**PRODUCT NOTICE****Notice of Potential Product Concern**

## Basic Peer-to-Peer Communication False Detection of Link Failure with Potential for Shutdown of Trusted Controllers

Reference: 2021-02-004

Trusted T811X

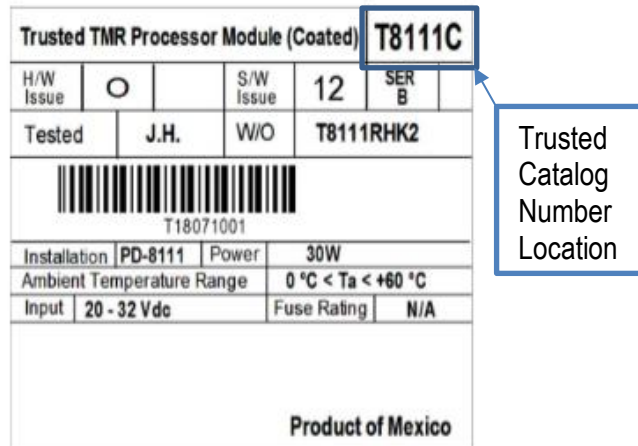
The affected product is firmware versions up through 4.000 for Trusted processors, catalog numbers:

- Trusted T8111C
- Trusted T8110\*

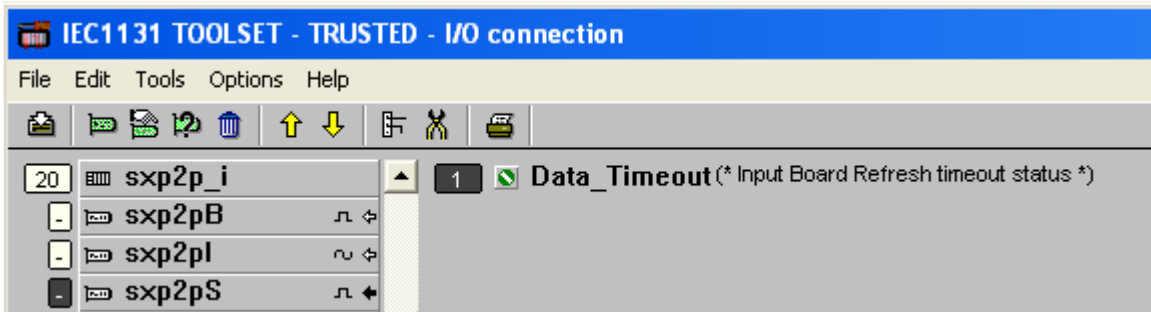
An anomaly exists where the basic peer-to-peer timeout values can expire within one application cycle and recover on the following application cycle. This however can be long enough for link failures and data timeouts to be reported. If a multi-SIS controller architecture is configured to fail safe on loss of communications AND has a single SIS controller managing the entire basic peer-to-peer network, then this anomaly can result in shutdowns being initiated.

- For Simplex link applications – This workaround assumes that the “input refresh status” variable (see example below) is used in the application to initiate a trip, in accordance with the guidance provided in Table 21 of [ICSTT-RM454](#)). This variable (on each sxp2p\_i board) is ‘locked’ and set TRUE (i.e., force this status variable healthy), then this will prevent the application generating a shutdown condition should this reported anomaly occur.

- For Redundant link applications - This workaround assumes that the “input refresh status” variable is used in the application to initiate a trip (logically AND 'ed with its parallel input refresh status variable for redundant link configurations), in accordance with the guidance provided in Table 21 of [ICSTT-RM454](#)). These variables (on each pair of sxp2p\_i boards) are 'locked' and set TRUE (i.e., force these status variable healthy), then this will prevent the application generating a shutdown condition should this reported anomaly occur.

Correction requires updating product firmware to a later version. Rockwell Automation is working on a corrected version of firmware and will release it to the Rockwell Automation Product Compatibility and Download Center (PCDC) in the future. If you would like to receive a notice when this version is released, a link is provided at the end of the Knowledgebase article for this Product Notice.
